Recall Bulletin

PRODUCT SAFETY RECALL

SUBJECT: Rear Suspension Bolts May Not Be To Proper Torque Specification

MODELS: 2013 Chevrolet Malibu

Fastener Location Overview

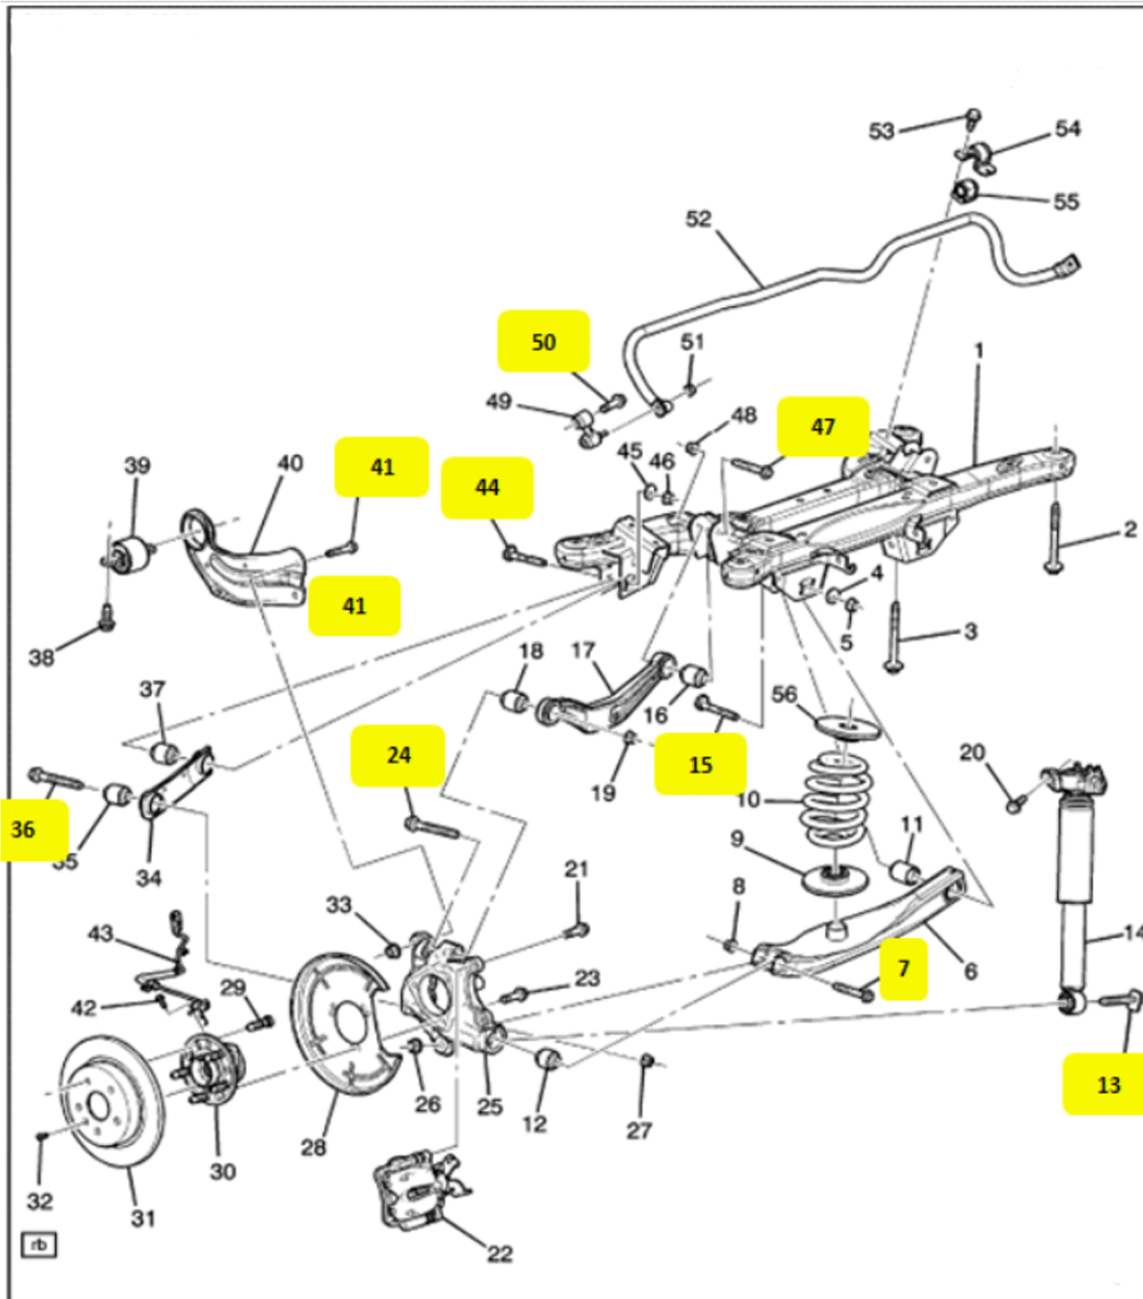
3. Perform a static torque inspection on the 20 rear suspension fasteners listed in the *Static Torque Specification Table* in this bulletin.
 - Ensure the 20 fasteners meet the minimum static torque specification provided in the table. Refer to the table to determine if torque must be applied to the bolt or nut.

- Replace ALL fasteners that do NOT meet the minimum torque specification with a new fastener. The fastener part number is provided in the *Parts Information* section of the bulletin.

FLO Illustration Number.	Bolt Reuse	Bolt Name	Bolt P/N.	Nut P/N	Static Specification Min (Nm)
13	No	Rear Shock Absorber to Knuckle	11611099		170 Nm
50	Yes	Rear Stab Bar Shaft Link	11518630		50 Nm
44	No	Rear Suspension Link Inner	13219181	11094488	100 Nm
36	No	Rear Suspension Link Outer	11561300		130 Nm
15	No	Rear Suspension Lower Control Arm Inner	13219184	11094488	100 Nm
7	No	Rear Suspension Lower Control Arm Outer	11609607		90 Nm
41	No	Rear Suspension Trailing Arm to Knuckle	11589355		160 Nm
Opposite to 41	No	Rear Suspension Trailing Arm to Knuckle	11589355		160 Nm
47	No	Rear Suspension Upper Control Arm Inner	11589279	11516078	80 Nm
24	No	Rear Suspension Upper Control Arm Outer	11611105		190 Nm
